ACCESSION NBR: 8307050022 DOC. DATE: 83/06/15 NOTARIZED: NO DOCKET #
 FACIL: 50-397 WPPSS Nuclear Project, Unit 2, Washington Public Power 05000397
 AUTH. NAME AUTHOR AFFILIATION
 BOUCHEY, G. D. Washington Public Power Supply System
 RECIP. NAME RECIPIENT AFFILIATION
 SCHWENCER, A. Licensing Branch 2

Subject: NUCLEAR PROJECT NO. 2
DRAFT TECHNICAL SPECIFICATION

TECHNICAL SPECIFICATION LOG ITEM RESPONSES

FIGURE 3 PEAK VESSEL PRESSURE VERSUS SAFETY VALVE CAPACITY

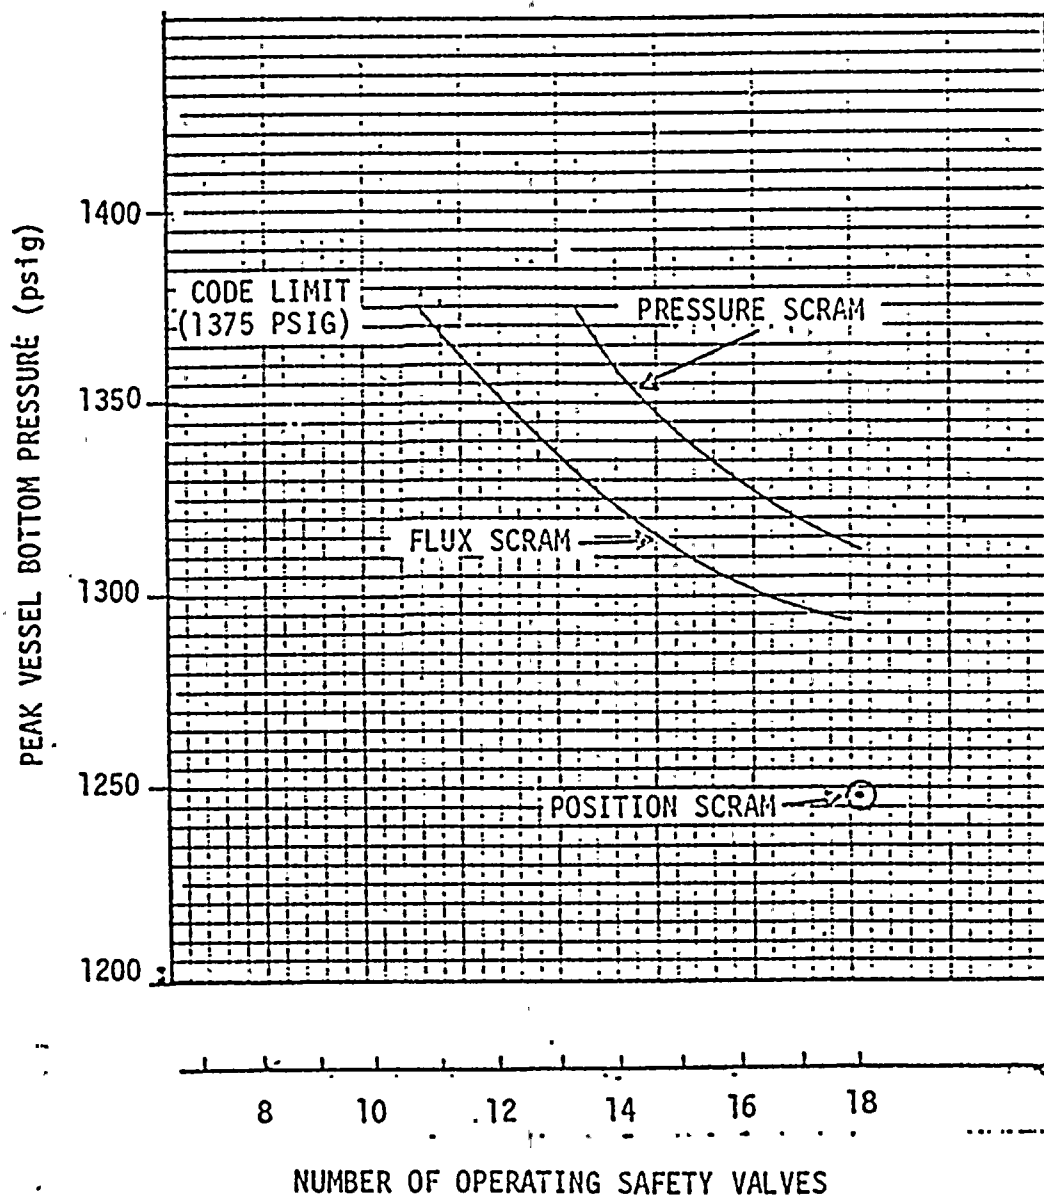
Item #17: Reactor Vessel Overpressure Protection Design Report, Document 22A4106, Rev. 2, states that a MSIV closure with scram signal derived from indirect means (flux versus directly from MSIV closure logic) is the most severe overpressure transient. The analyses results, indicated on Figure 3 and FSAR Figure 5.2-4, indicates that 12 operating safety relief valves are required to limit the pressure response to less than the code limit of 1375 psig. A copy of the document is attached for your information. Note that Susquehanna Tech Spec requires 10 of 16 valves operable.

In addition, the Reactor Vessel Overpressure Protection Analysis was redone using the ODYN code. This analysis shows a 28 psi improvement (reduction) in peak vessel pressure assuming a MSIV-flux scram initiating event. Using standard GE design practice of applying a 40 psi design margin to code pressure limits results in a peak pressure analytical limit of 1335 psig. With the 28 psi improvement from ODYN, the analytical pressure transient as a function of safety relief valve capacity intersects the analytical limit at 11+ valves required operable. Therefore, 12 SRVs was selected as the minimum operable number of valves.

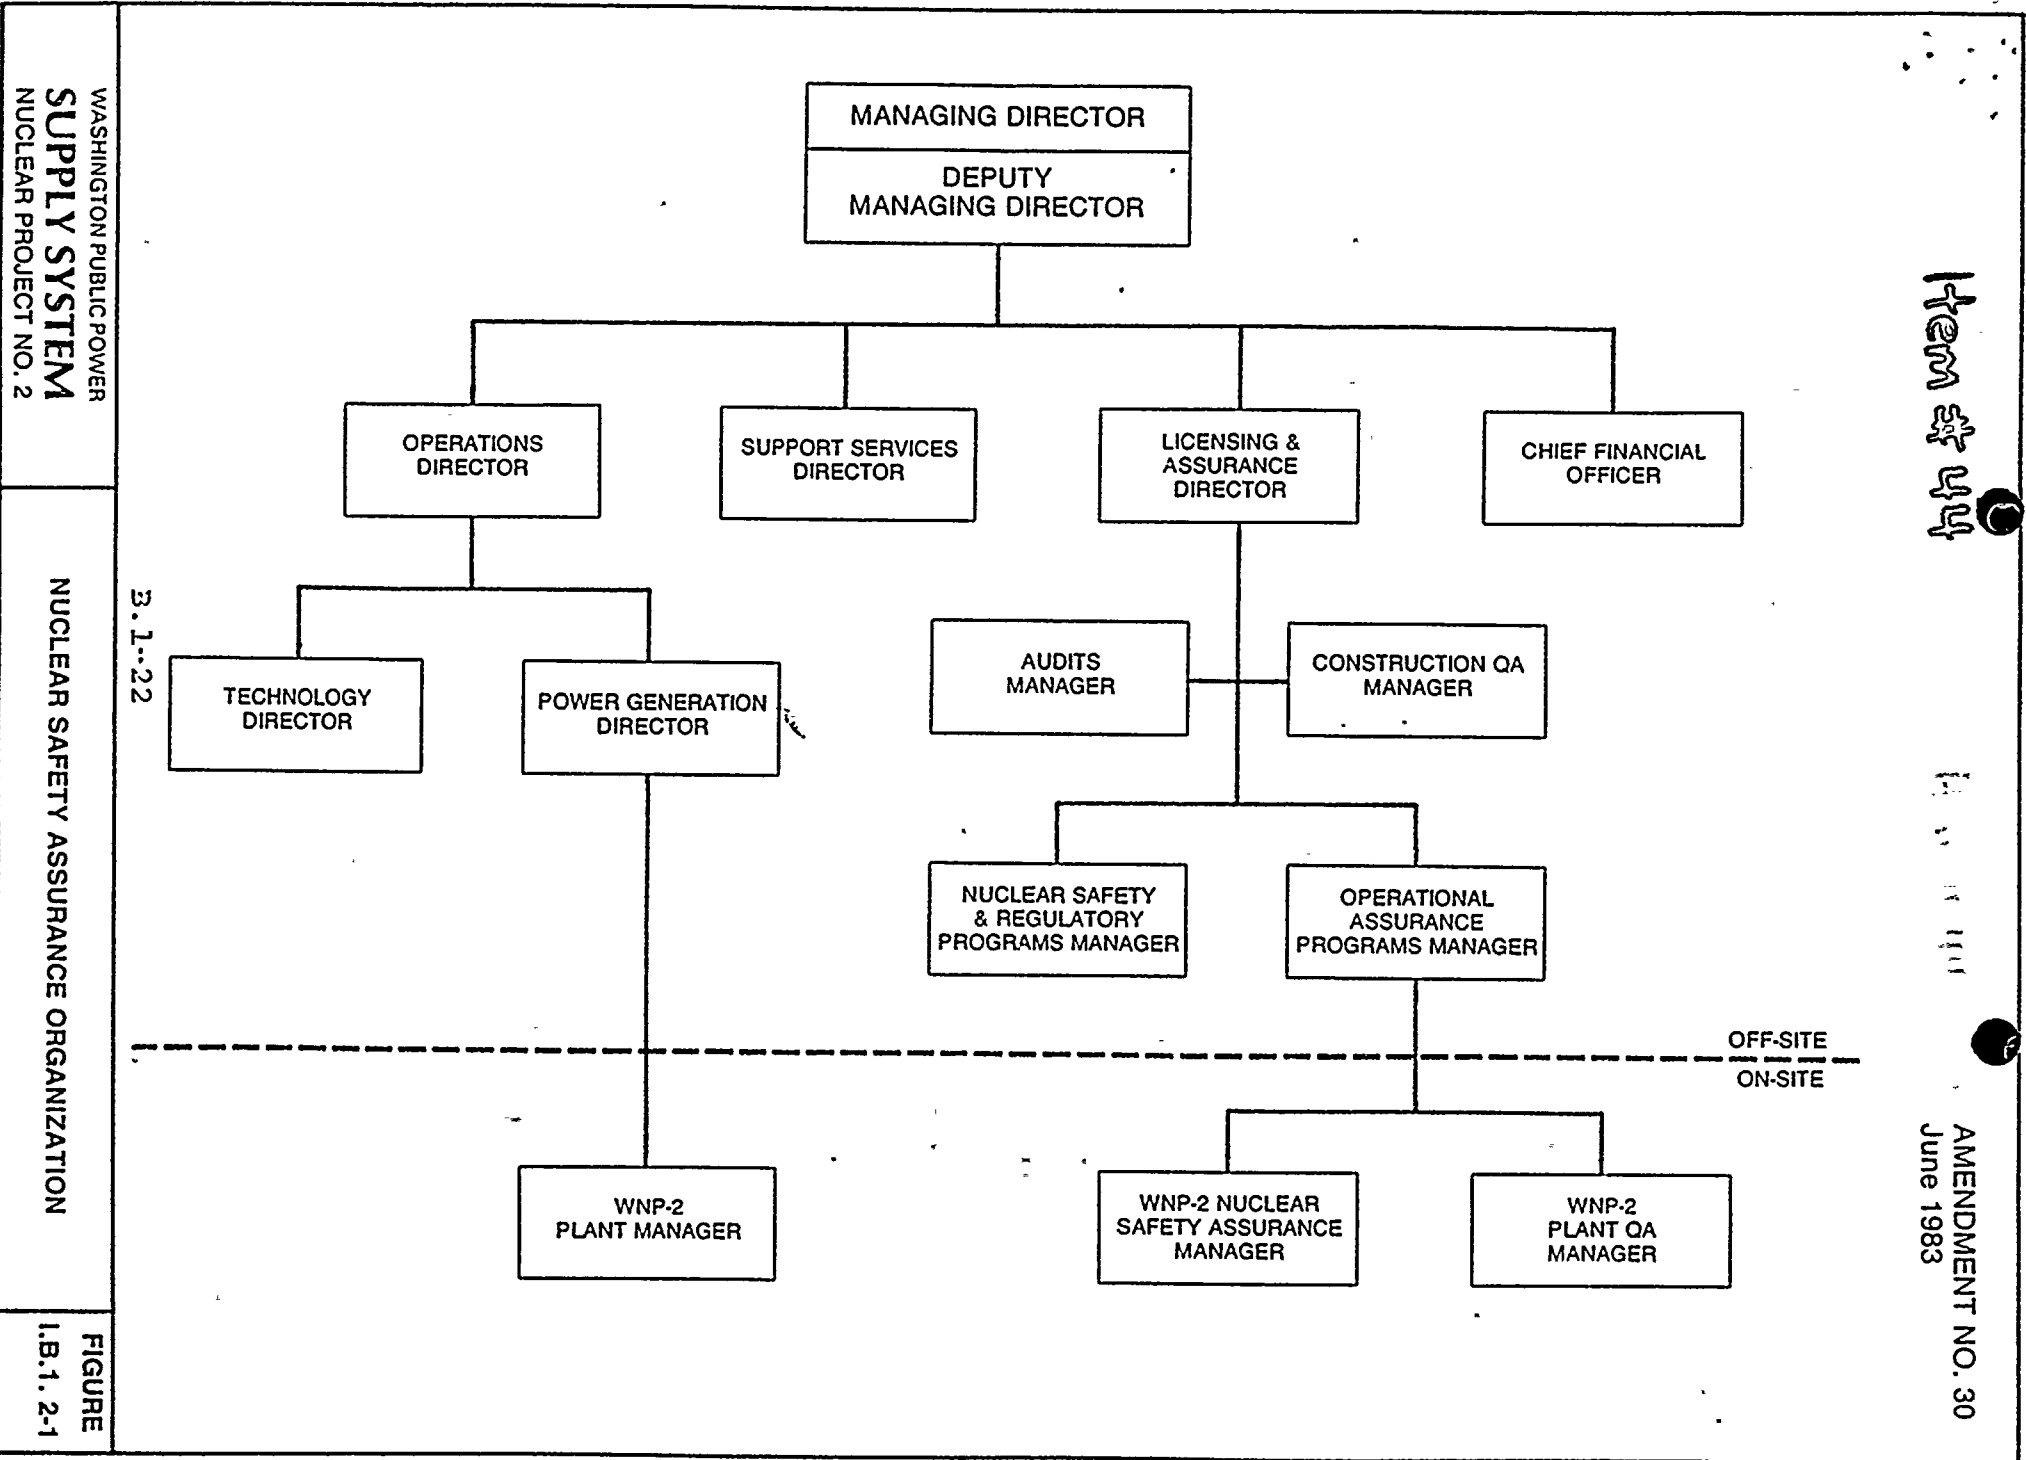
Item #44: WNP-2 FSAR Chapter 13 has been recently revised and germane sections of the SER should be reviewed for compliance. With respect to the organization charts submitted in the Tech Spec, an organization chart in Appendix B is attached for your information and to illustrate Tech Spec submittal compliance.
